PCN No.: 150331PCN-TR04(E)

Process Change Notification

Content: Halogen Free for VMT3/ EMT3F/ UMT3F package Transistor:

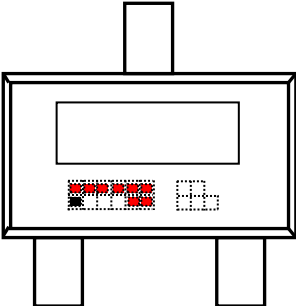
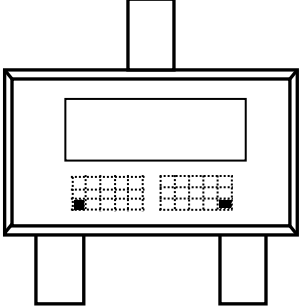
(Current)	(After change)
Mold resin	- Bromine-based flame retardant epoxy resin	- Halogen Free Epoxy resin
<u>Label indication</u>		
Lot No.	1545 ***** Week code indicates with first 4digit numbers.	Week code from 1545
<u>Marking on product</u>	<p>(13/ 17 dots type)</p>  <p>Week code indicates with dot marking. ex) Manufactured in 45th week, 2015</p>  <p>* VMT3 package is 13dots.</p>	
(30 dots type)	(Not exist 30 dots type for current spec.)	<p><u>30 dots type is only HF spec.</u></p>  <p>■: Base dot</p>
